Advisory Design Panel

Memorandum

To: Advisory Design Panel
From: Graeme Buffett
Re: 1476 Beach Drive

f) DP000026 – 1476 Beach Drive

FRONT BALCONY RAILING ELEVATION
SCALE 1:10

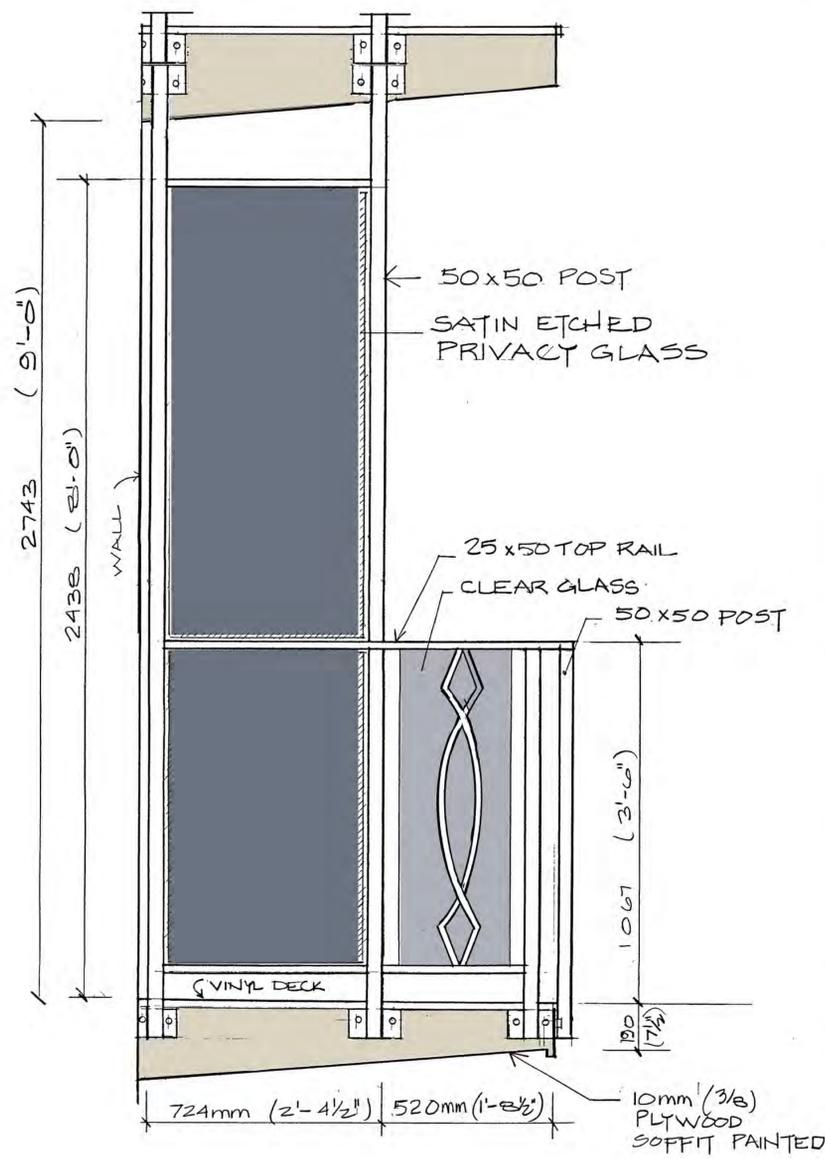
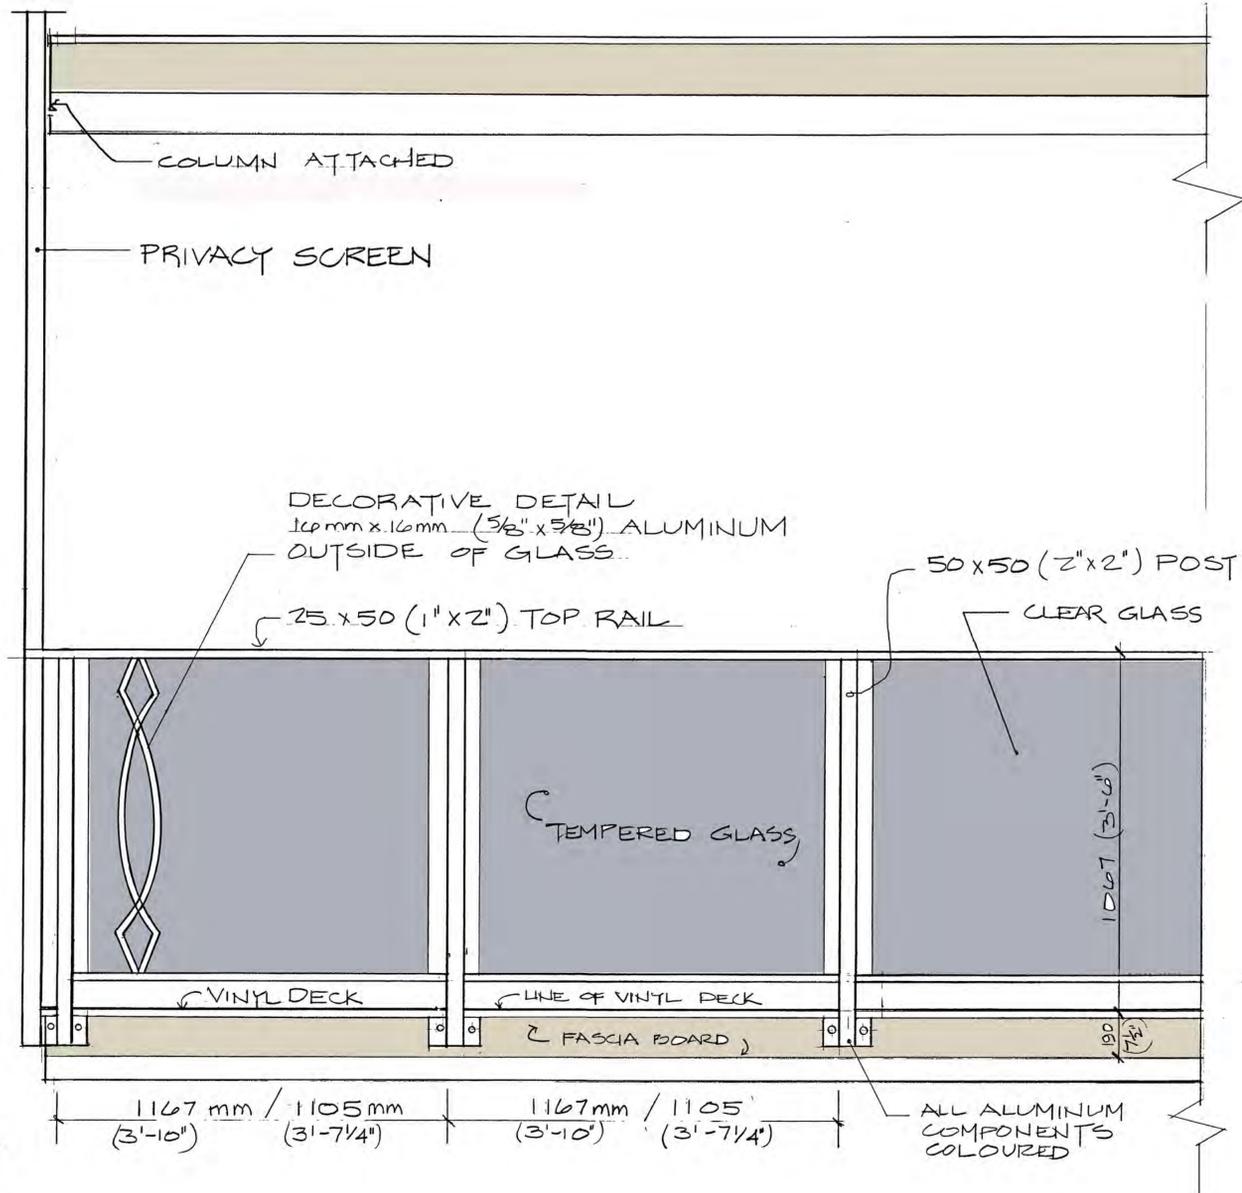
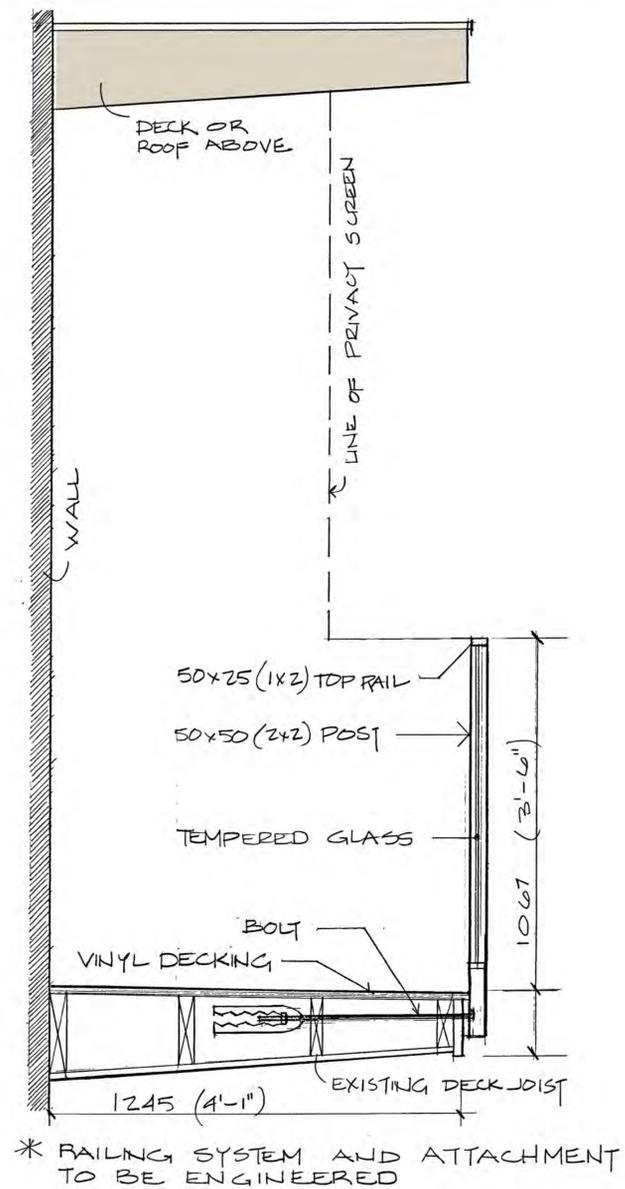
- Concerned with replacing something unique with something with less character.
- Not enough detailing for rails or end panels provided; proposal is underwhelming.
- Consider corner details (ie. metal corners for outside corners), solid looking design, soffit material, end screens are important.
- Consider a modular system.
- Angularity works with the end panels that run full height, providing a sense of enclosure, end walls should not be competing (not stucco).
- Express 16 inch returns as fins.
- Consider overlaying balustrades like the existing, break it up with posts in between, similar to the original rendering.
- Consider additional variation, proposal detracts and has no rhythm, refinement needed.
- Consider maintaining existing railing.
- Consider a hybrid fabrication that provides wind screen and appropriate height.
- Confirmed the vinyl decking will be replaced.

BALCONY RAILING ELEVATIONS
 SCALE 1:10

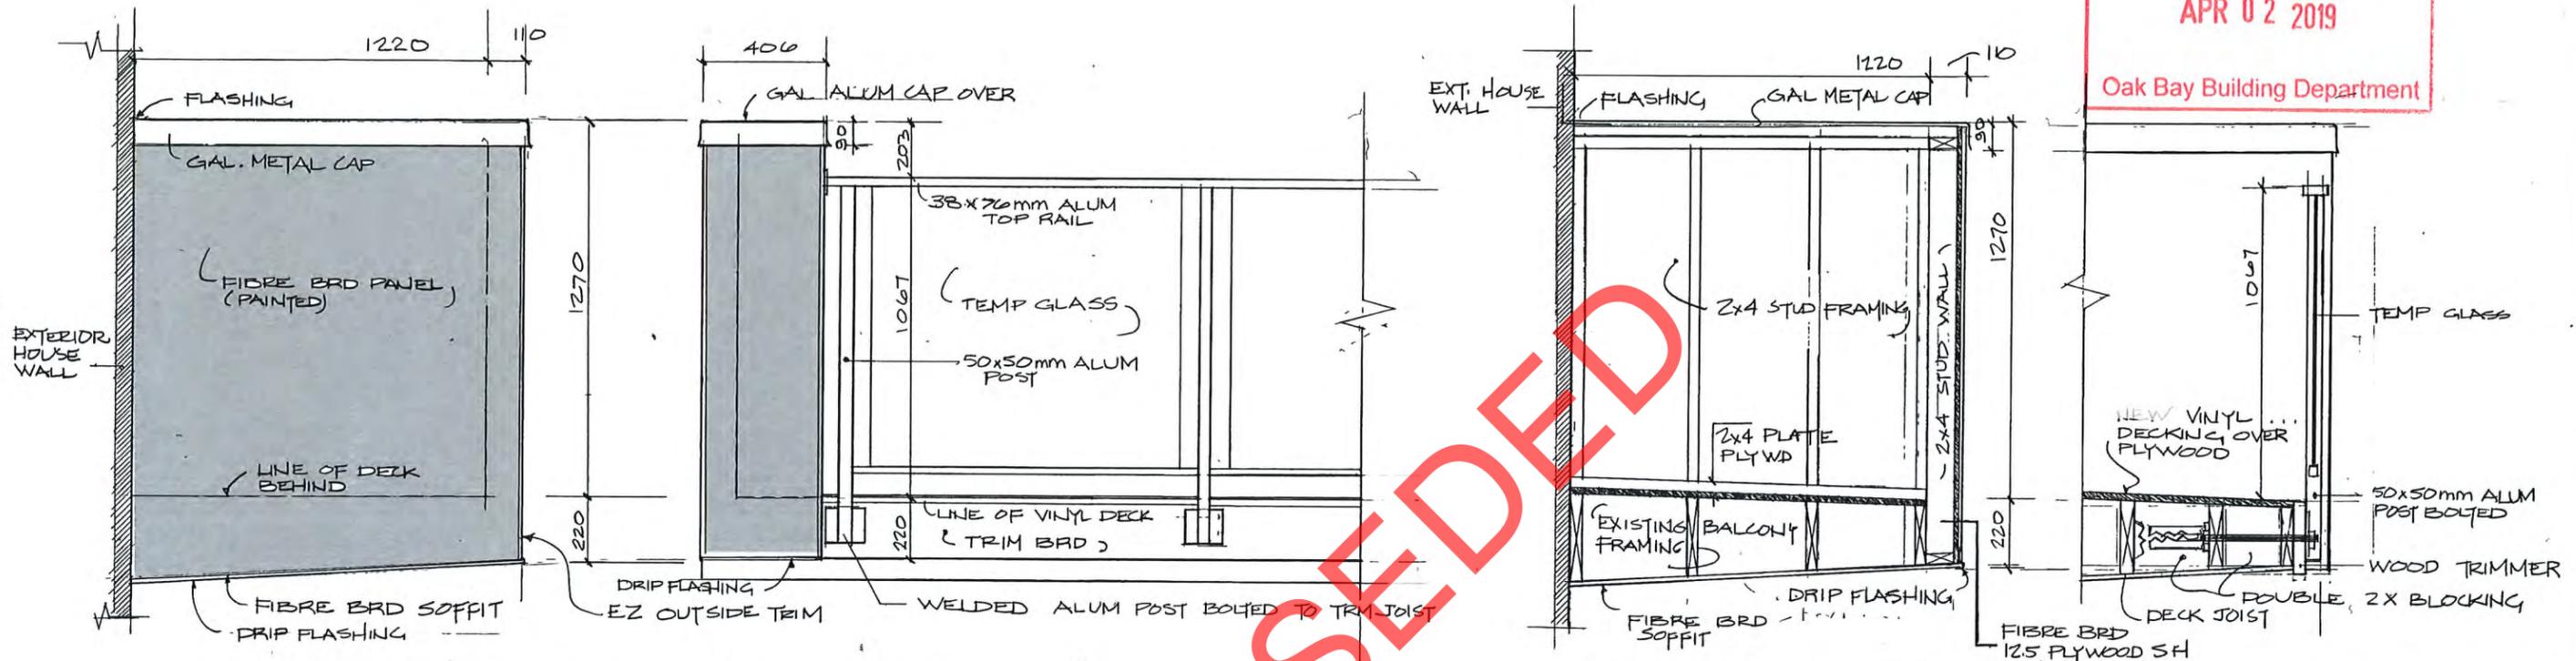
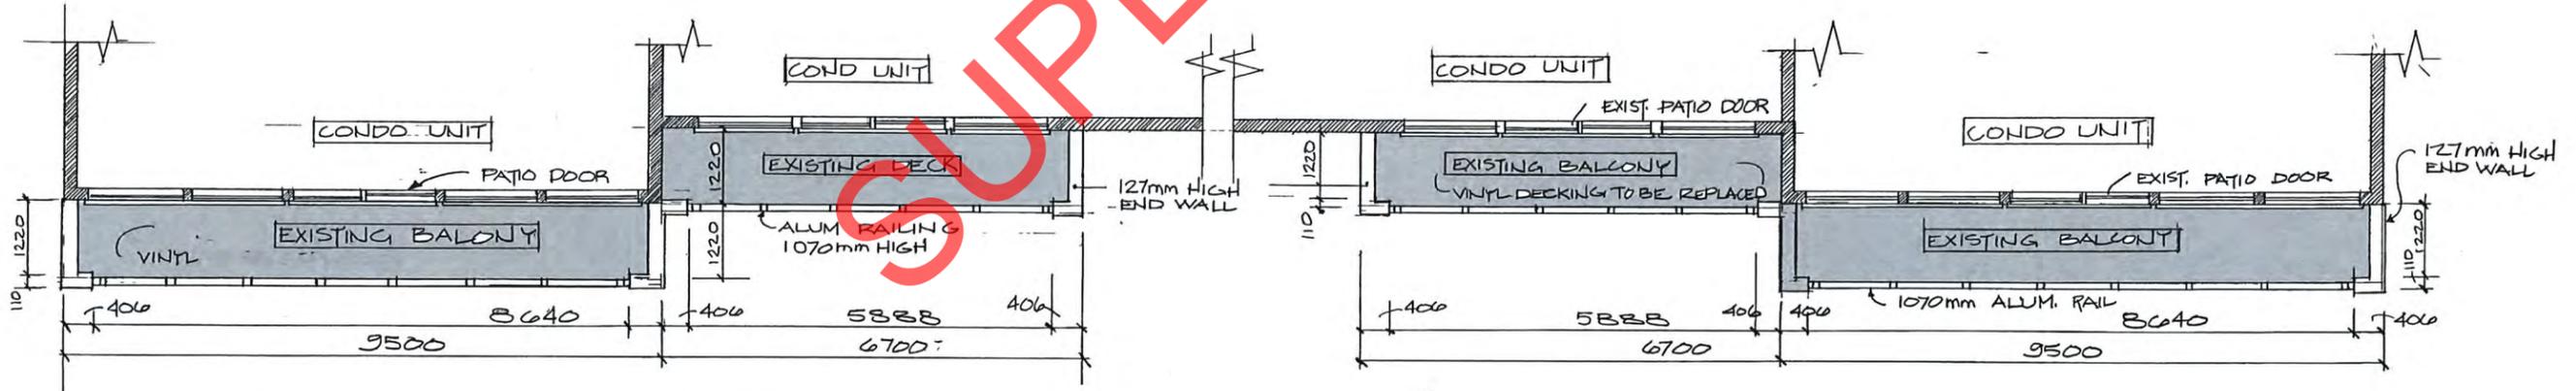
- Comprehensive, consistent railing system only.
- Delete end pony walls.
- Use full height posts at ends to accommodate full height screens where desired.
- Consider replacing clear glass with opaque or coloured glass, and incorporate perforated metal pickets.
- Must be a consistent organizing modular system.
